**ADDENDUM #8  
BID NO. 2009-V**

**Project: Ellisville Water System Improvement – Expansion to US 441**

**Response to Request for Additional Information #2**

**RE: Ellisville Water System Improvement  
Expansion to U.S. Highway 441  
Request for Additional Information #2**

# Temporary construction sign for American Recovery and Reinvestment Act (ARRA) projects

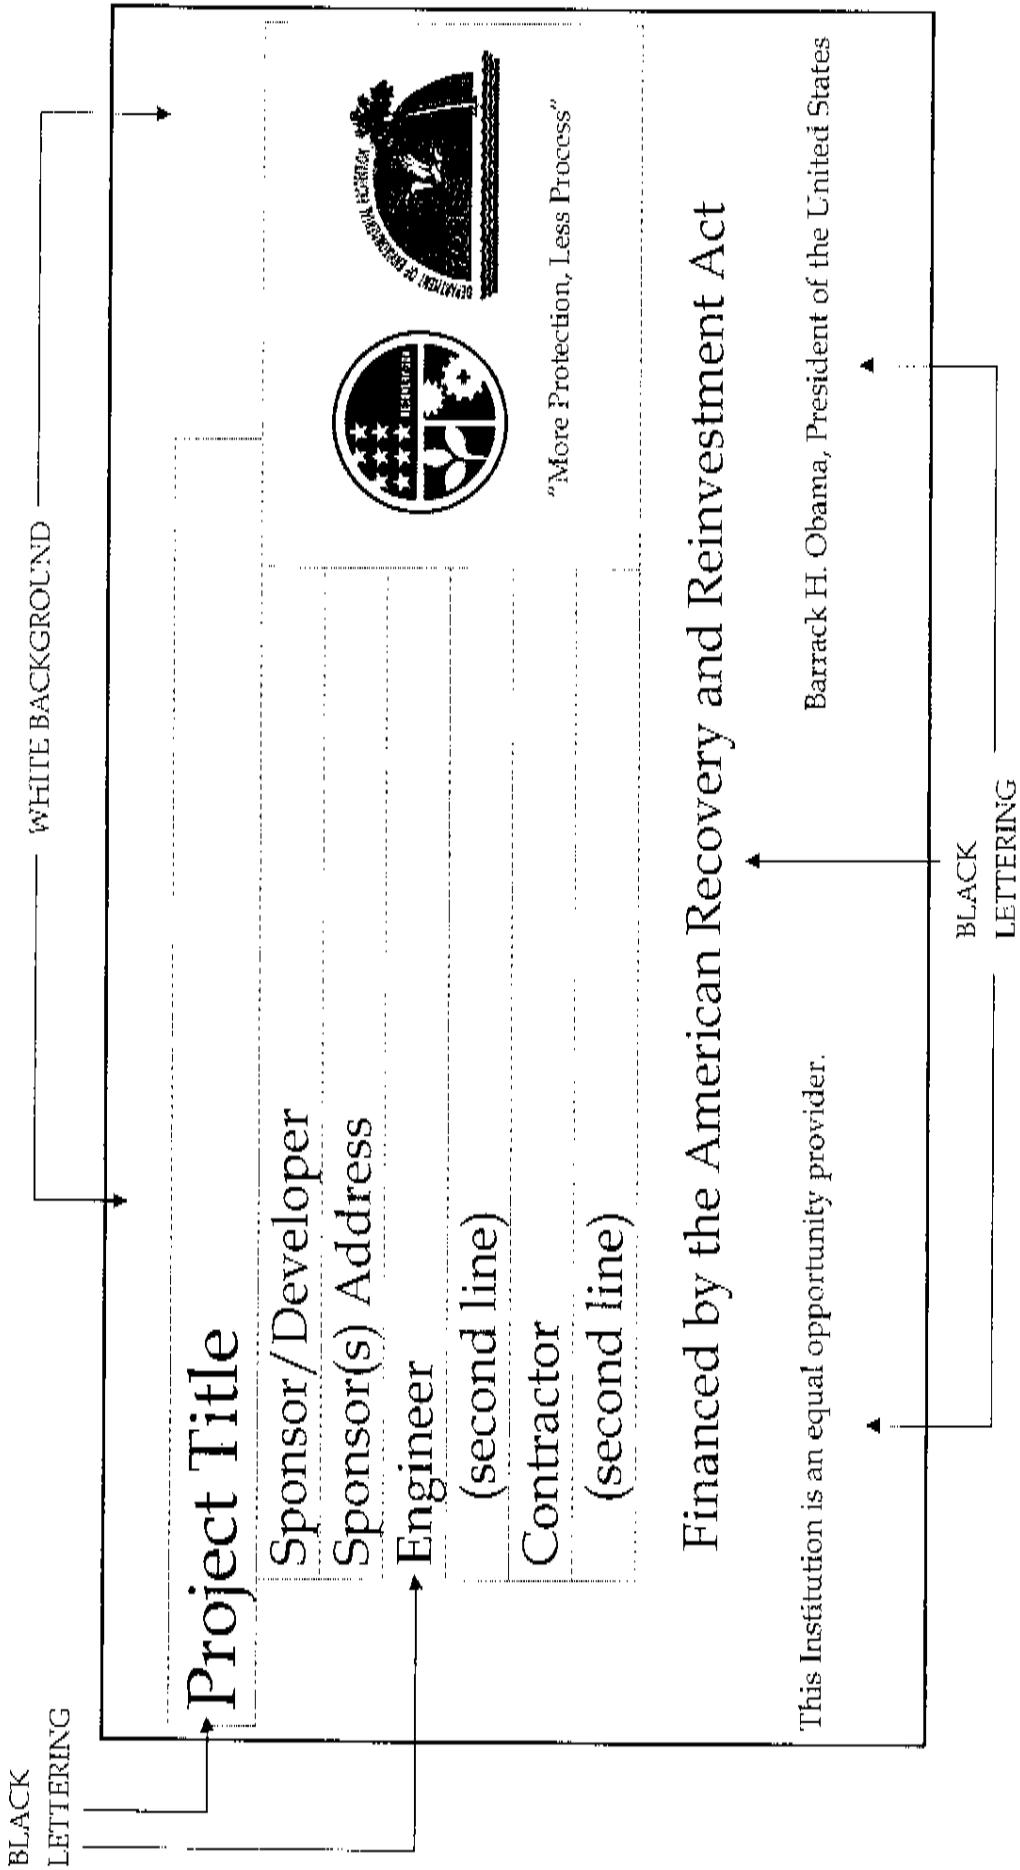
1. In the specifications for both the 441 and I-75 projects, it is stated that the contractor is responsible for providing a project sign. The specs go on to say that the sign will be in accordance with the enclosed drawing and that the sign will be erected at the System office. You can find this on page 00400-3 for the I-75 and 441 projects.

- a. I don't see the enclosed drawing for the design of the sign. Do you have this?

**Attached to this addenda is a sample of the required sign.**
